INITIAL FIRE SAFETY INSPECTION REPORT

Kenpark Bangladesh (Pvt) Ltd. (Extension)

RSC ID: 24856

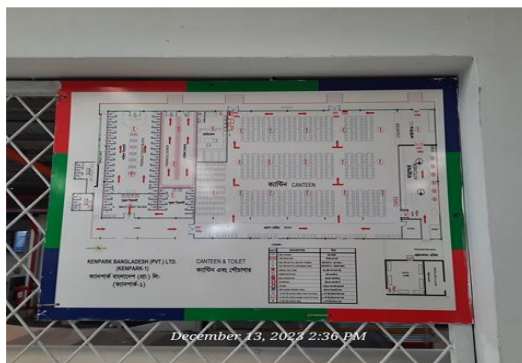
F-02	Fire Rated Construction	Chemical room is found at 2nd floor of 3D building which is not separated by fire rated construction and opening protective. Location: 3D building	Chemical storage room shall be separated from other occupancies by a minimum 4-hr fire rated construction (wall, floor, slab etc.) and no openings and penetrations shall be permitted at fire rated wall, floor, slab etc. with other occupancies.	Within 6 months

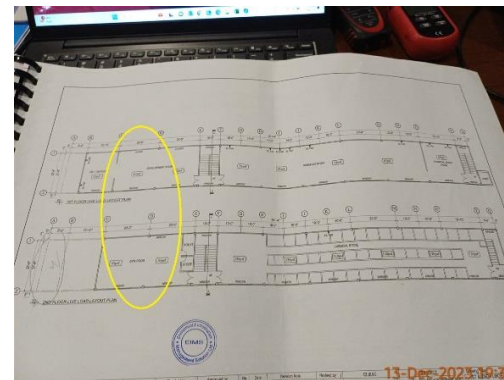
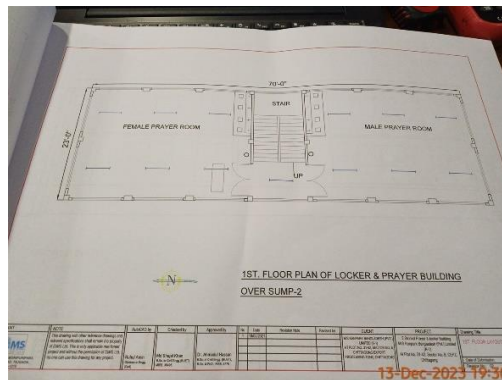
F-04	Fire Rated Construction	Exit corridor serving main production building (East side exits), canteen building (both exit discharges from stairs), prayer and locker building and 3D building are not fire separated.	1. Separate the corridor by a minimum 1-hr fire rated construction. Or 2. Provide automatic sprinkler system throughout the stories as per NFPA 13.	Within 3 months
------	-------------------------	---	---	-----------------

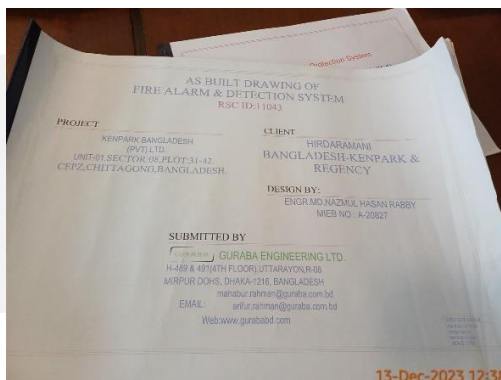
F-12	Means of egress	The stairs serving the 3D building have a width less than the required minimum of 0.9 meter (36 inches). Location: 3D building.	Stairs shall have a minimum width of 0.9 m (36 in.)	Within 6 months
